SUBJECT: 25-040 Loaf Land Subdivision - Comment Response

Thank you for your continued review of the Subdivision Application Permit (SP 4103) for Loaf Land Subdivision in Coplin Plt.. The team recently received the additional review comments from LUPC in regard to this application, dated August 27, 2026. These comments can be seen below in *italic*, followed by Main-Land's response in regular typeset. Updated or amended exhibits have been provided as attachments.

GRADING &
EROSION
CONTROL PLAN

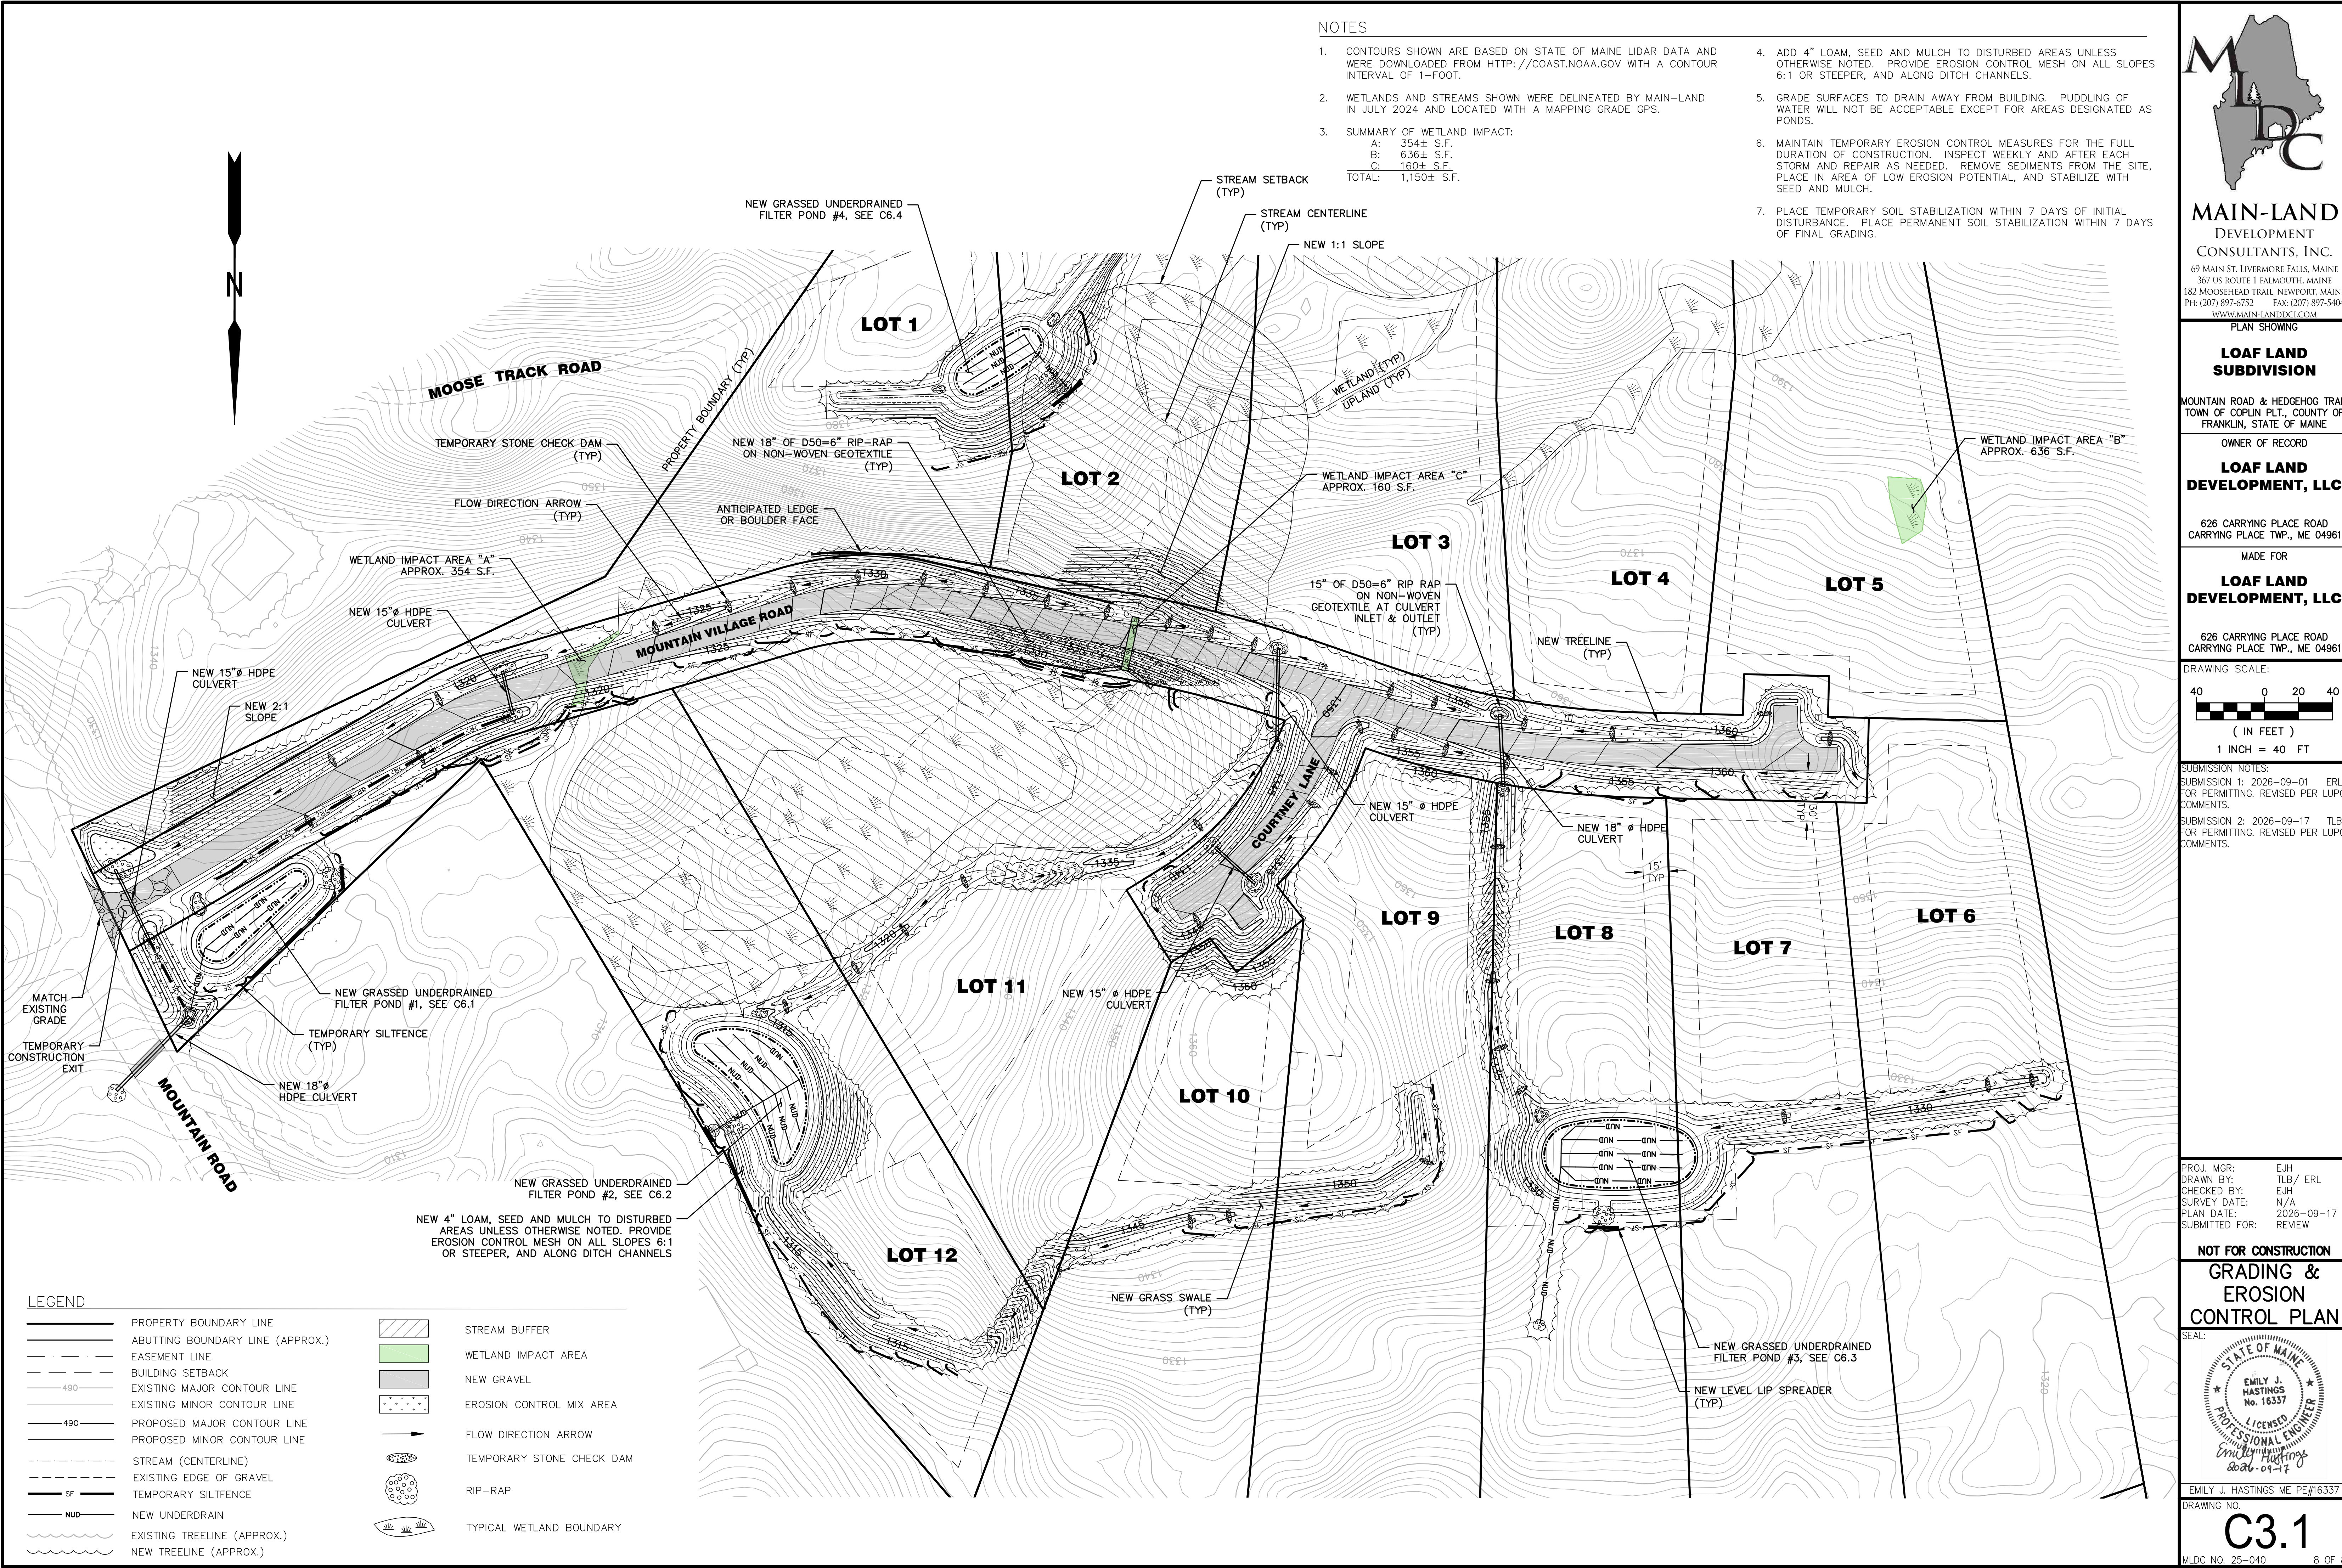
- *On Plan C3.1 (Grading & Erosion Control Plan), wherever side slopes exceed 3H:1V, show the planned slope stabilizing measures and their extents (see Sebago Technics review comment IV.11 on Sheet C5.3).*
 - *Sebago Response: The stream profile appears to indicate the need for a 7 foot-tall wing wall on the outlet side. The plans should better depict the design intent of this wingwall and how wetland impacts will be avoided during its construction. Silt fence is also shown through the wetland in this area with no stated wetland impact in this area. Additionally, the design plans include lengths of side slopes that are at 2H:1V or steeper. It should be shown on the grading plan which slope stabilizing measures are to be used and their extents where the side slope exceeds 3H:1V.*

- *Wetland Alteration Supplement (Ex. 35)*
 - *Clarify the amount of wetland impact proposed. The Subdivision Plan (Ex. 10, S2.1) shows 354 sq ft (Note 11), the Grading Plan (Ex. 10, C3.1) shows 374 sq ft, and the Wetland Alterations Supplement (S-3) shows 514 sq ft proposed (Q. 7).*

The design plans have been updated accordingly to reflect those areas.

There is 990 sf of Forested Wetland impact and 160 sf of Stream impact, resulting in a total of 1,150 sf. All plan denotations have been updated to match the updated Form S-3.

**ROAD PLAN
AND PROFILE**

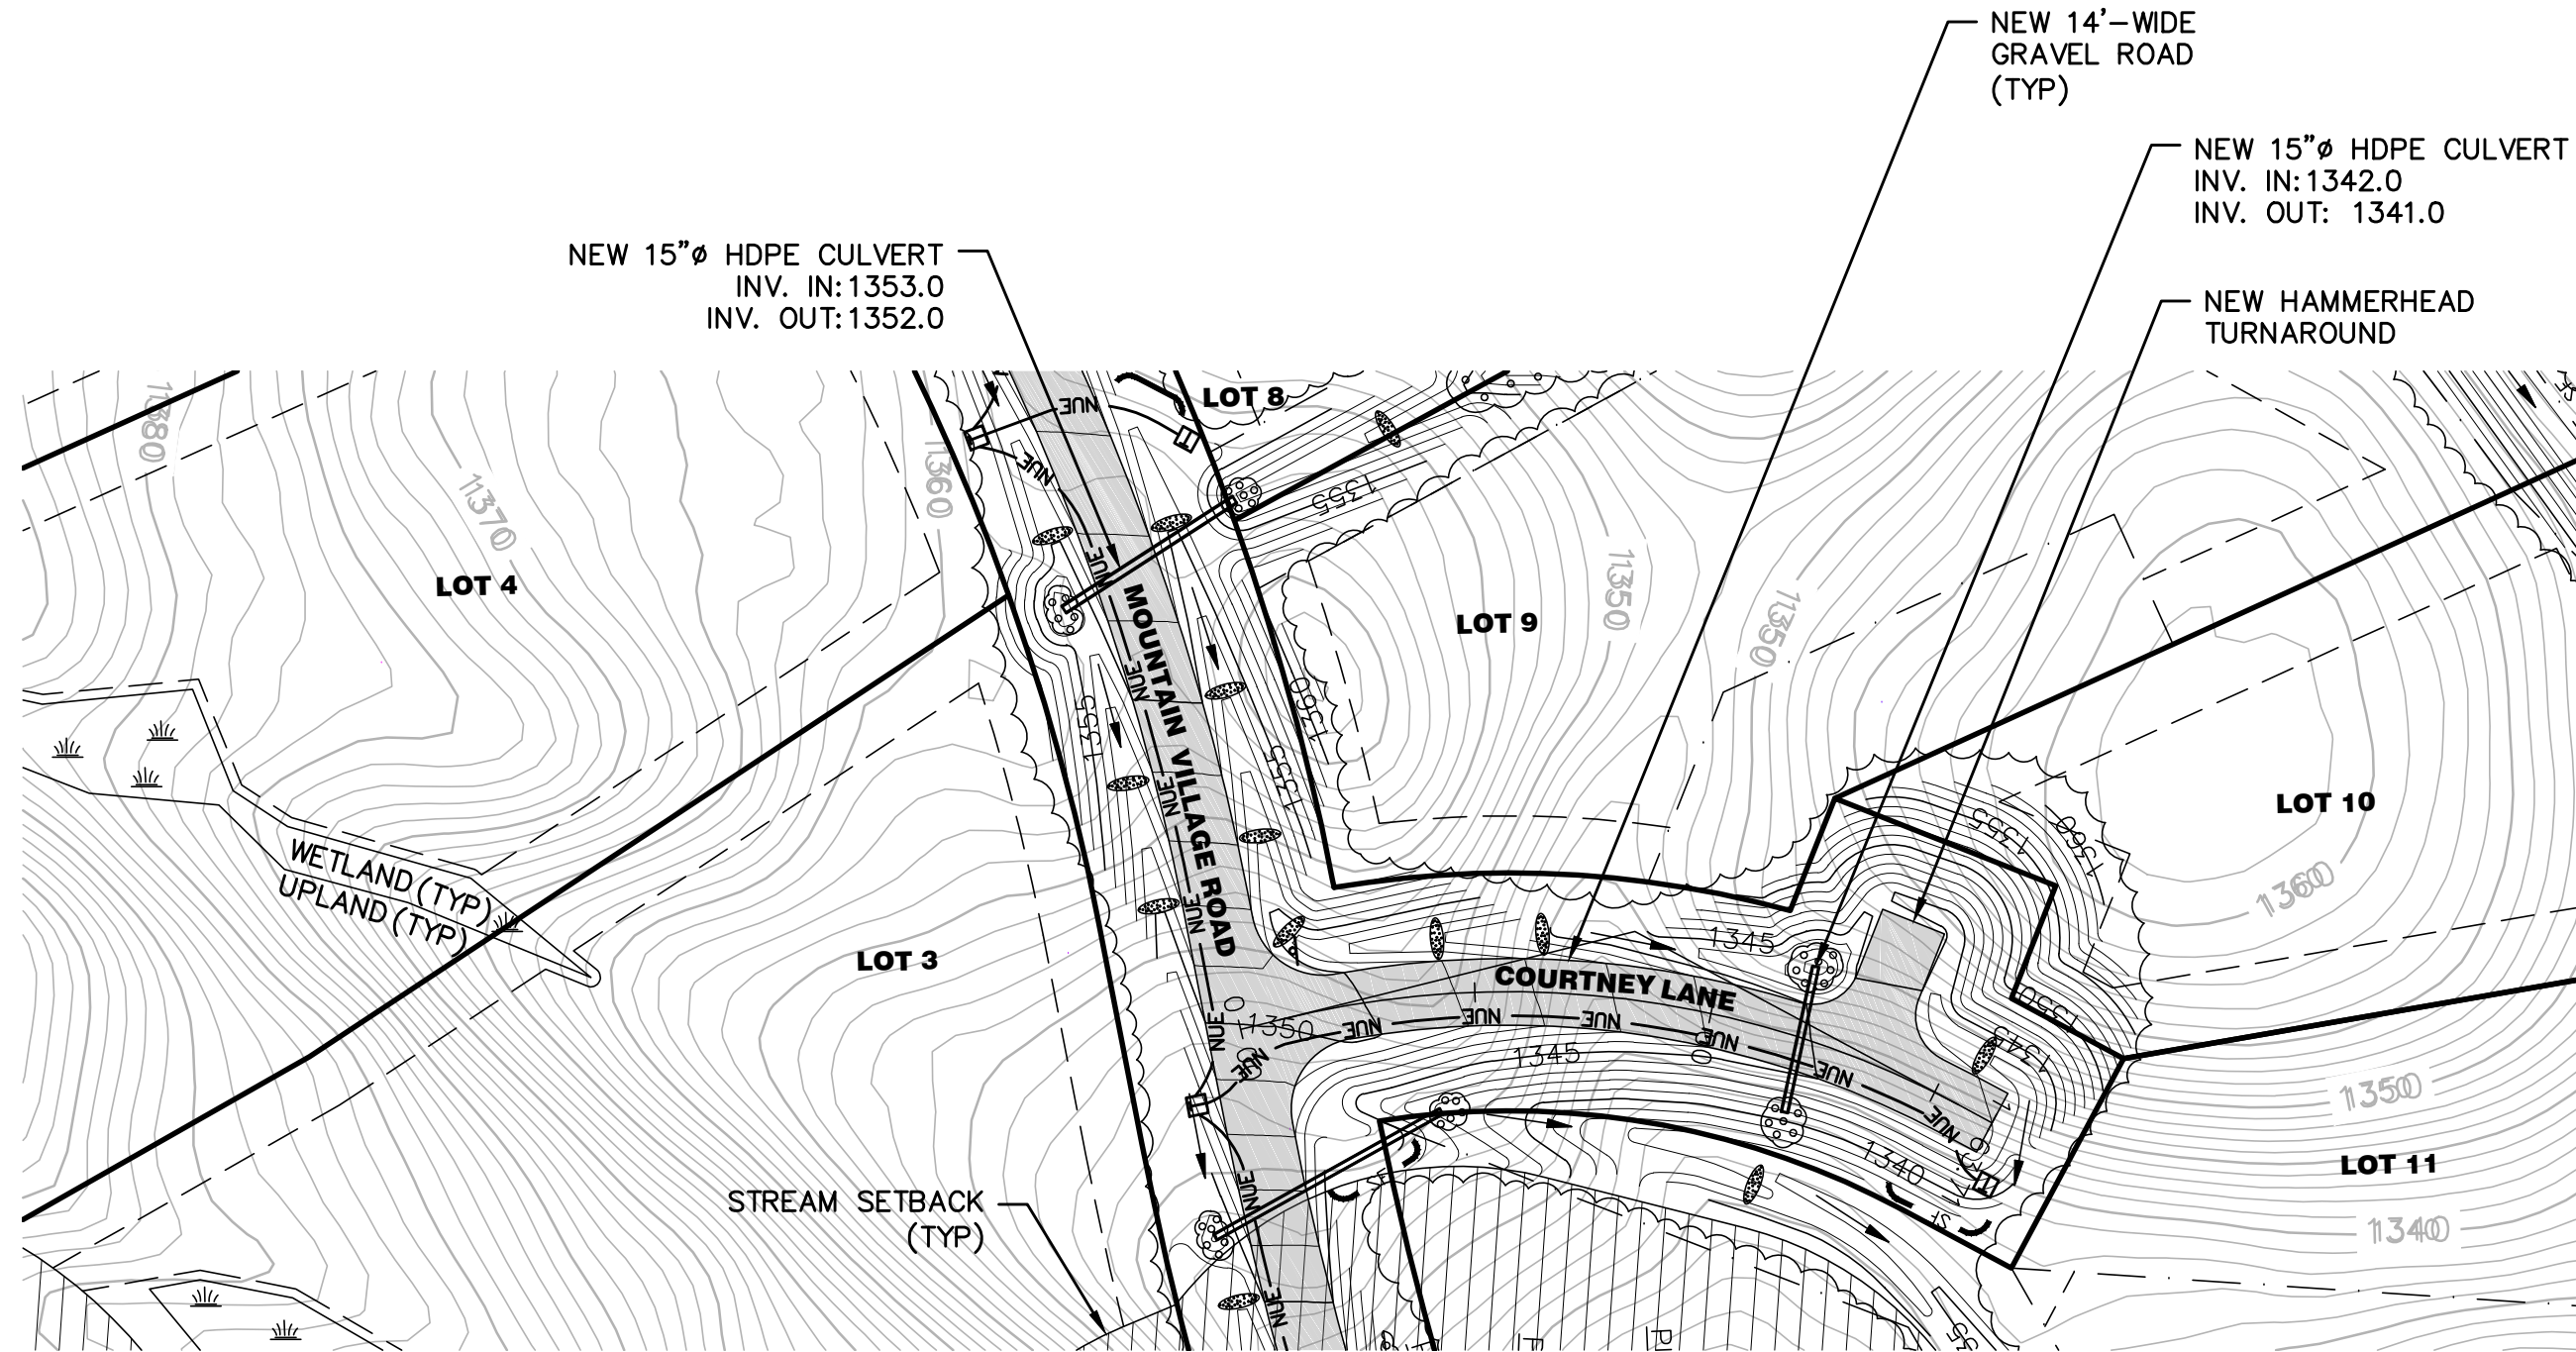
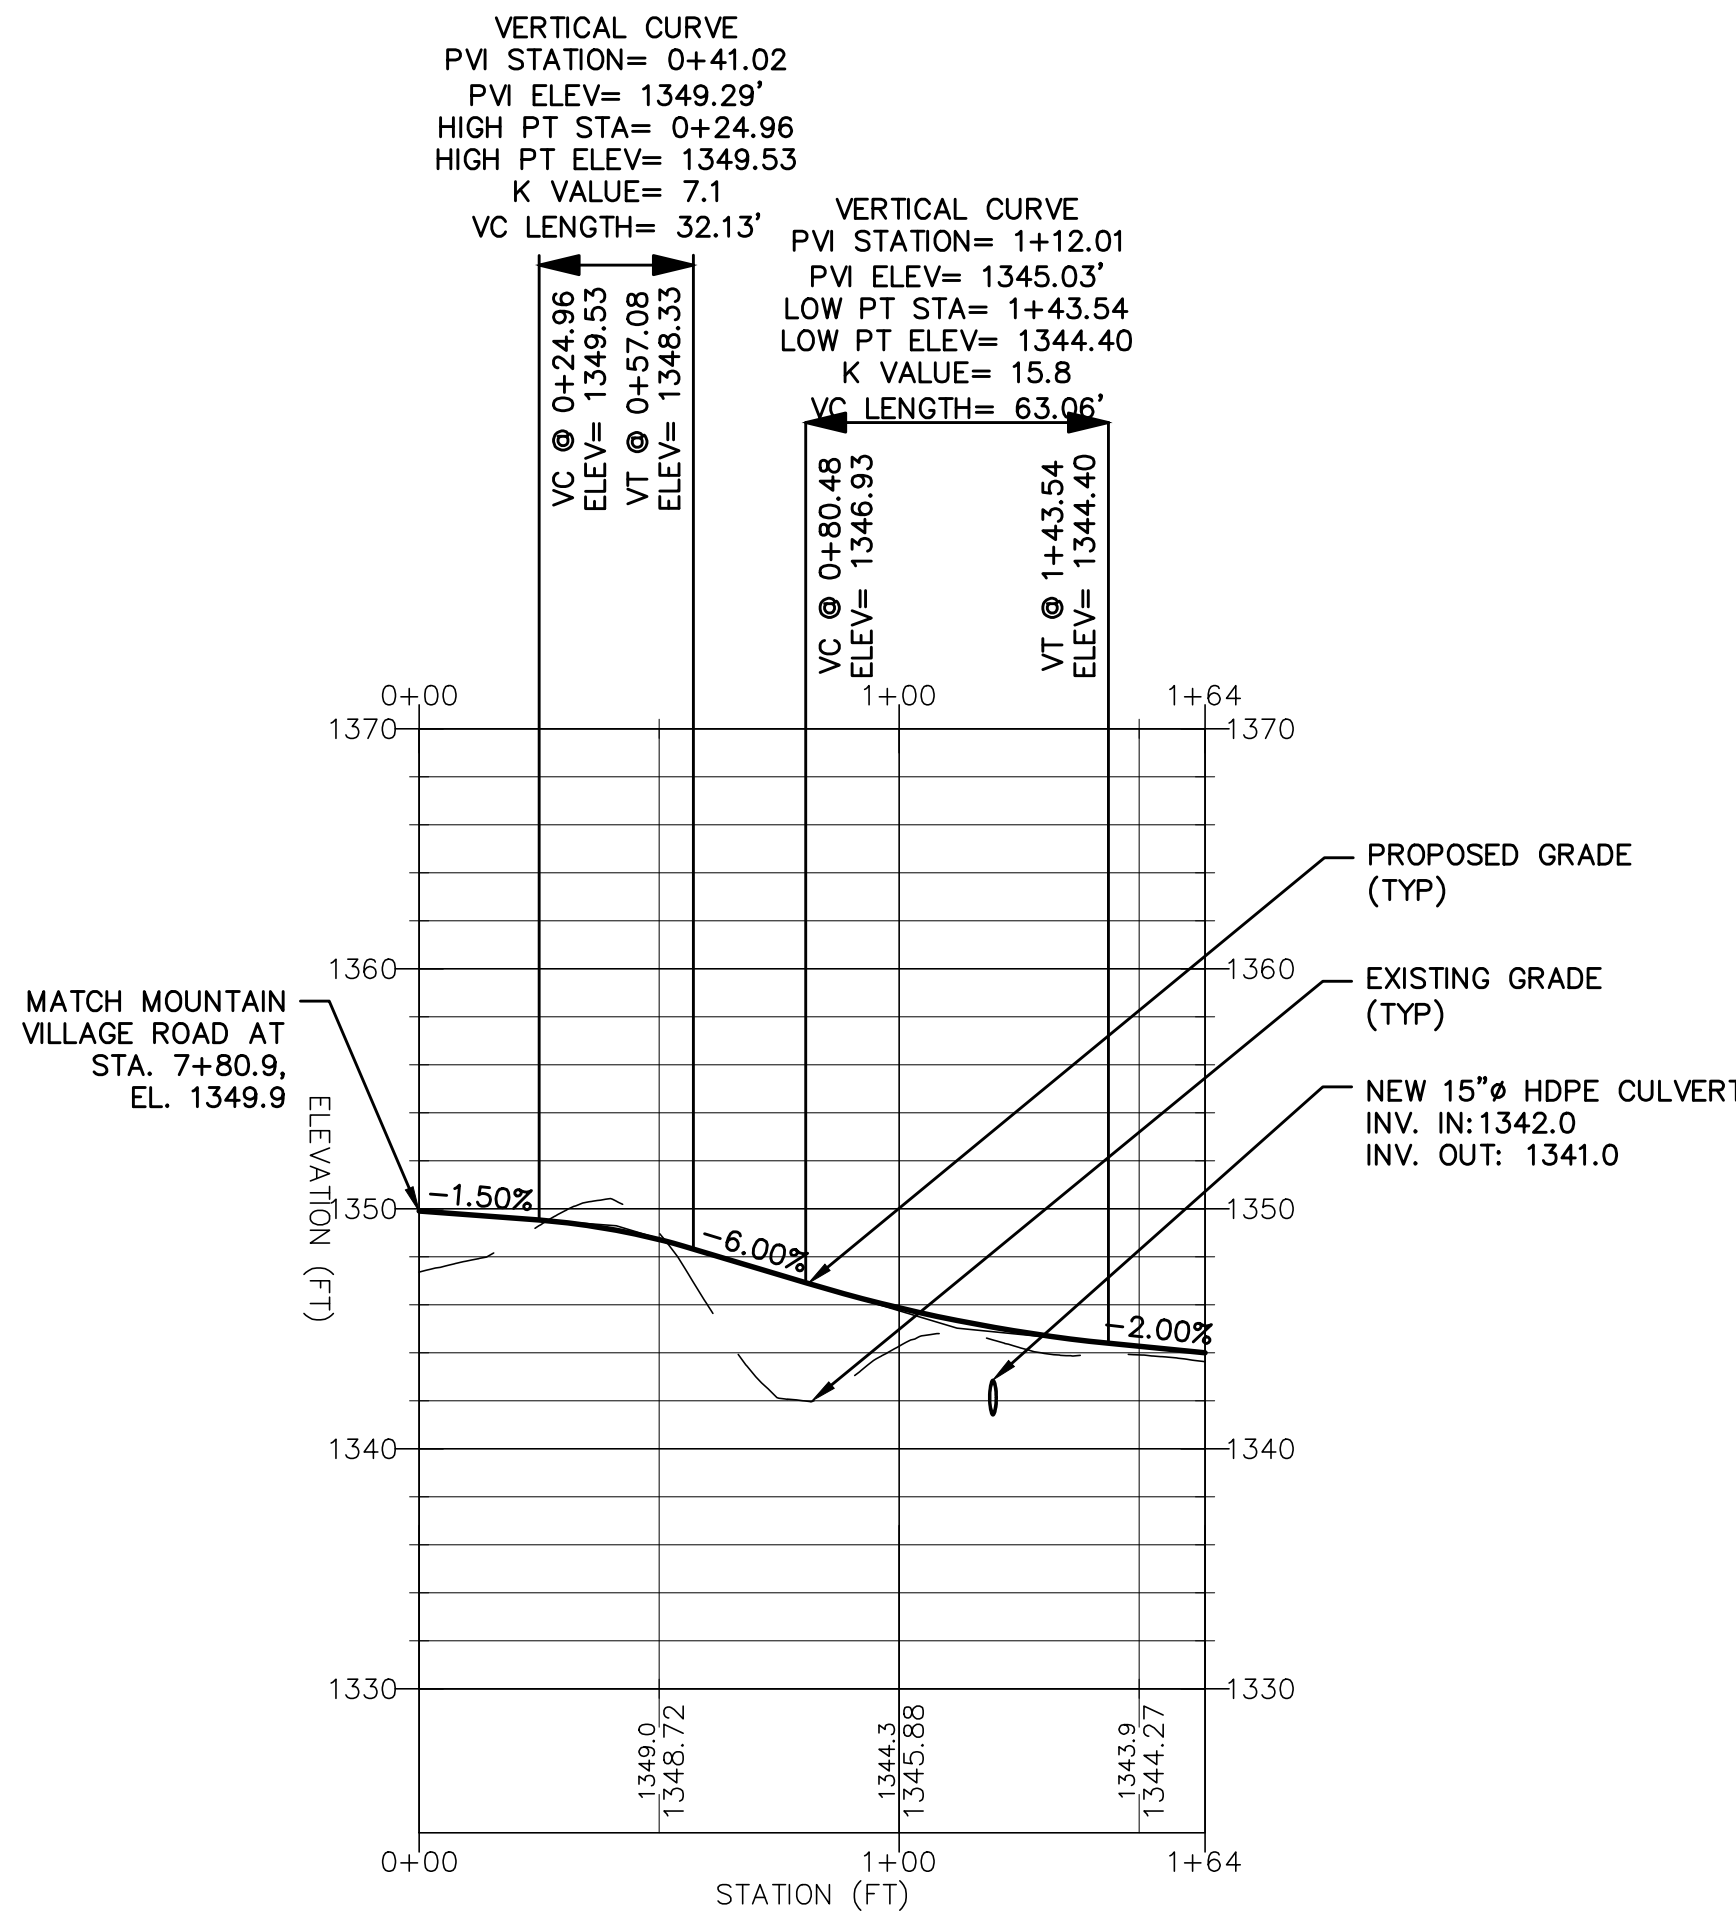
- *On Plan C5.1 (Road Plan and Profile), consider moving the proposed underground electrical conduit to either side of the ditch (see Sebago Technics review comment IV.12 on Sheet C5.1).*
 - *Sebago Response: The proposed electrical conduit is shown running down the centerline of the roadside ditch for Mountain Village Road. The designer should consider moving the conduit to either side of the ditch to avoid shallow cover and water intrusion.*
